ATTACHMENT 4

WMAL Transmitter Property

West Fernwood Citizens Association OFFICIAL COMMUNITY ACTION LIST

7/10/16 Rev 1.2

Figure 2 – Fernwood Road TTI

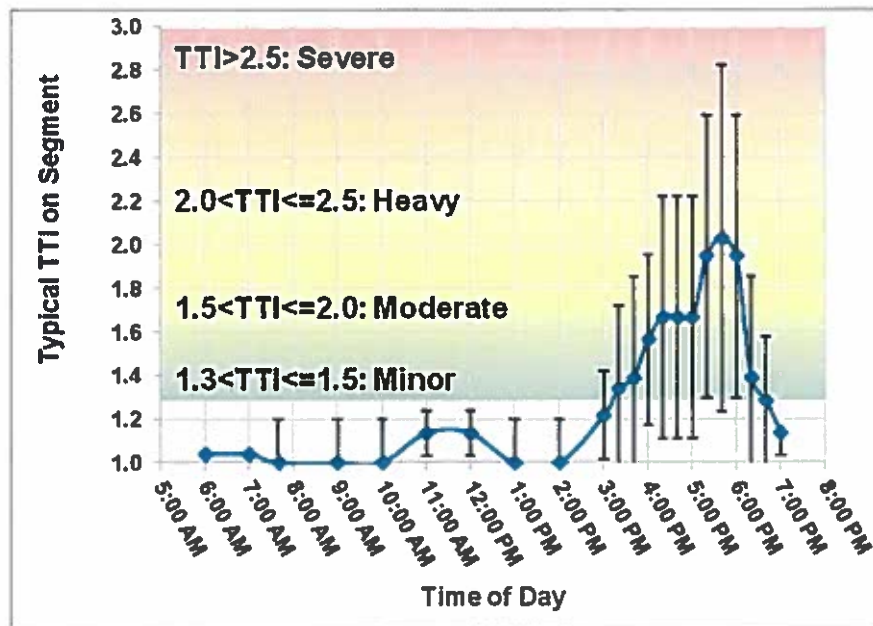
Anecdotally, the community finds it incredulous that the study concludes Fernwood Road (South of Democracy Blvd.) does not require any mitigation; it takes no more than a casual observation during most evening rush hours to see that there are obvious issues with the Democracy/Fernwood intersection.

A brief technical analysis making use of Google Maps finds that the typical travel time index (TTI) for this segment of Fernwood Road on Wednesdays can be greater than or equal to 2.0; according to the Metropolitan Washington Council of Governments (MWCOG), this is "Heavy Congestion". The calculated TTI versus time of day is shown in **Figure 2** below. Details concerning the analysis are included in this document as **Appendix B**.

Access to WMAL via Renita, and Connecting Renita to Greentree, will Drastically Impact Safety and Quality of Life for the Existing Neighborhoods

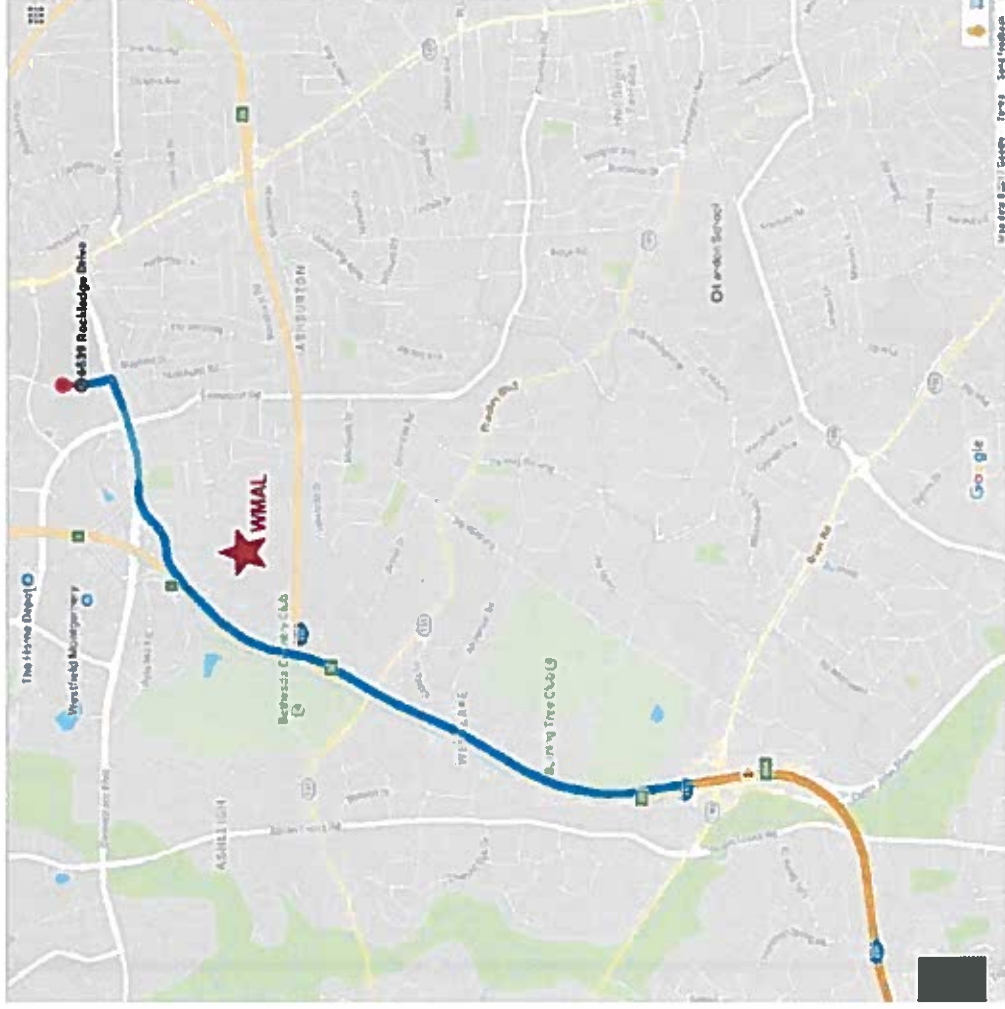
Renita Lane

Community Comments: Submitted Traffic Study

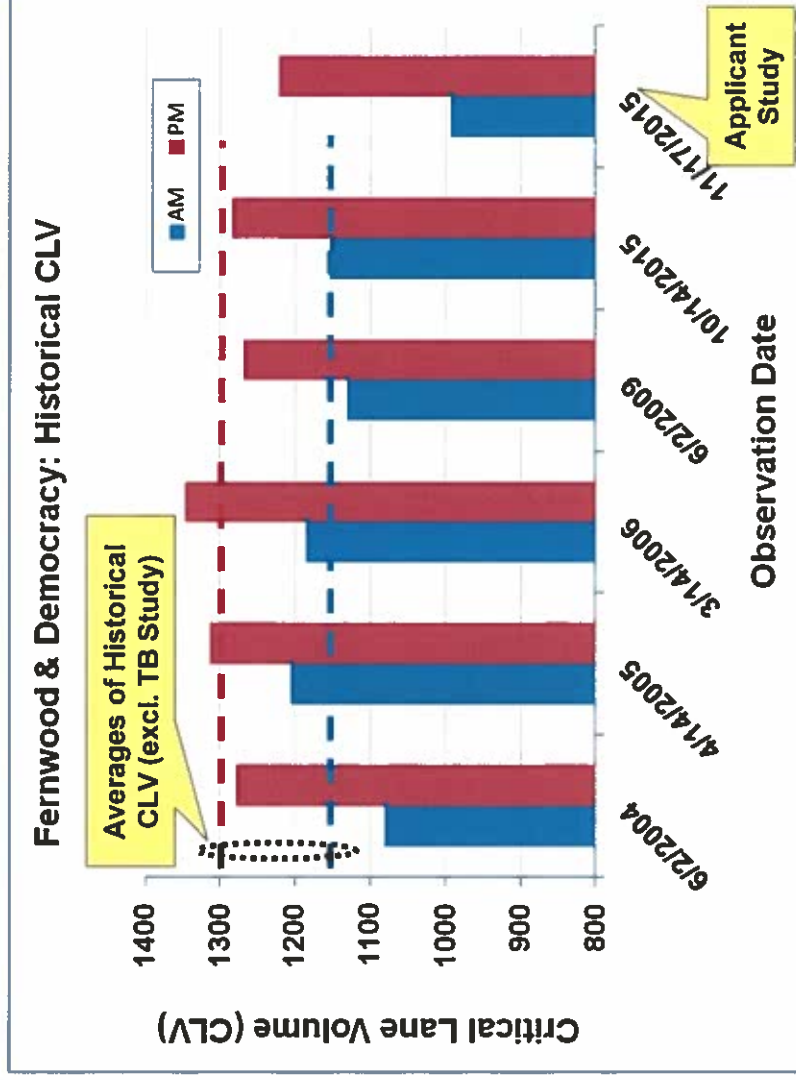
Independent of Planning Department Reaction to the WMAL LATR, Rationale for a Community Request for a New Study Includes:

1. The *existing* traffic counts collected for intersection of Fernwood & Democracy are anomalous, with respect to historical data – including an observation just 4 weeks prior to the Applicant's data
2. As many as **334** PM peak-hour trips are unaccounted for or improperly distributed in the Applicant's tabulation of *Background* traffic conditions for a single "pipeline" Project (Outbound PM trips for NIH Expansion)

Applicant Traffic Study Does Not Appear to Properly Account for Future Vehicle Trips from NIH Expansion at Fernwood & Democracy

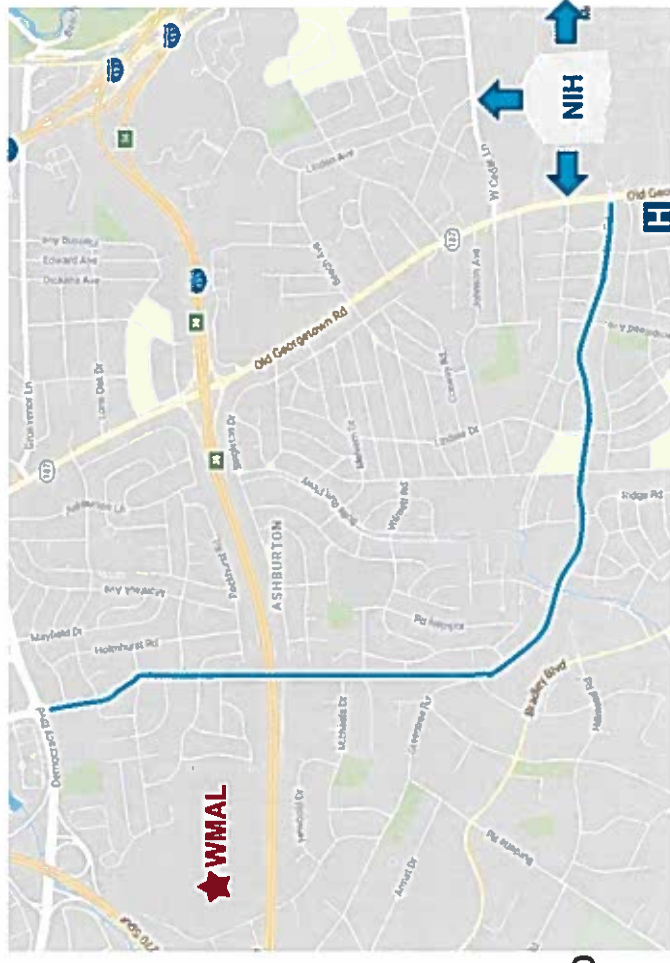
- NIH Expansion “Pipeline” Project Generates 4266 PM Vehicle Trips
 - 1364 In, 2902 Out
- Some of these vehicles travel through the intersection at Fernwood and Democracy
- Applicant Study does not provide trip distribution detail for the NIH Expansion Project
- Applicant is *not* allocating enough of these trips to Fernwood/Democracy when:
 - Using adjacent Suburban Hospital Pipeline Project as a model for the trip distribution; or
 - Using County Trip Distribution percentages from the 2013 TPAR & LATR guidelines

Study may be Missing Up to 334 PM Outbound Peak-Hour Vehicles (Originating from NIH) Turning Left onto Democracy From Fernwood Road

We Request a Government (unbiased) Operational Analysis² for the Segment of Fernwood Road between Bradley and Democracy Blvds.

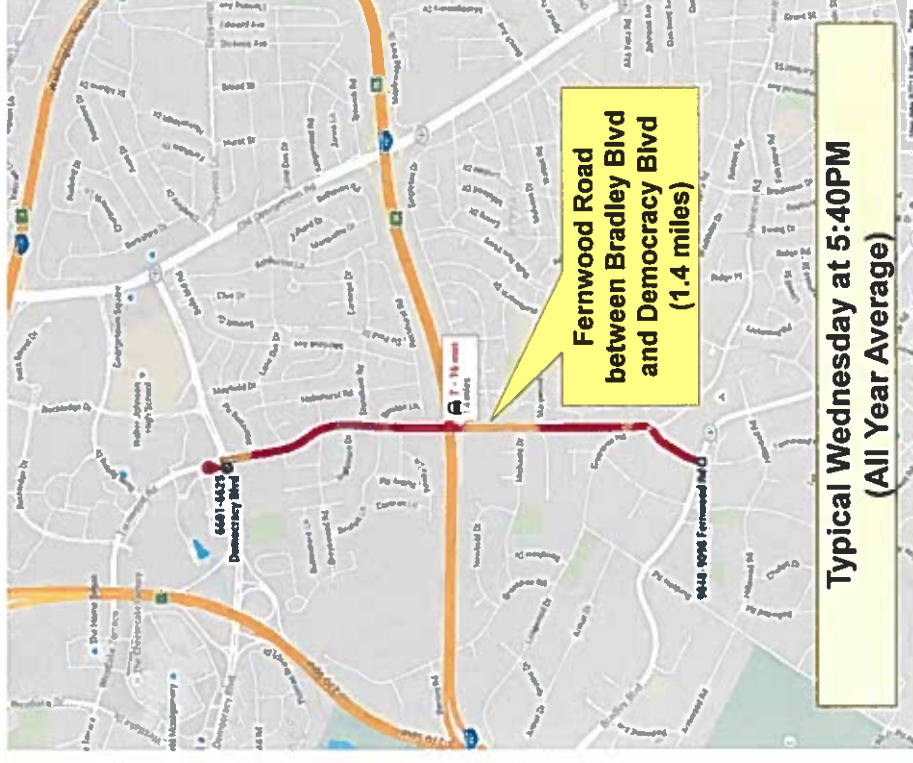
1. Google Maps “Big Data” analysis yields typical Time Travel Indices in excess of 2.0, which is “Heavy Congestion”, as defined by the Metropolitan Washington Council of Governments (MWCOCG)
2. Recent MCDOT speed studies appear to loosely corroborate the above “Big Data” results
3. Recent MCDOT volume measurements document that the volume on this segment significantly exceeds the capacity of the road’s design

If These Results Do Not Sufficient Conclude that Fernwood Road is Already Failing, We Request an Additional Operational Analysis²
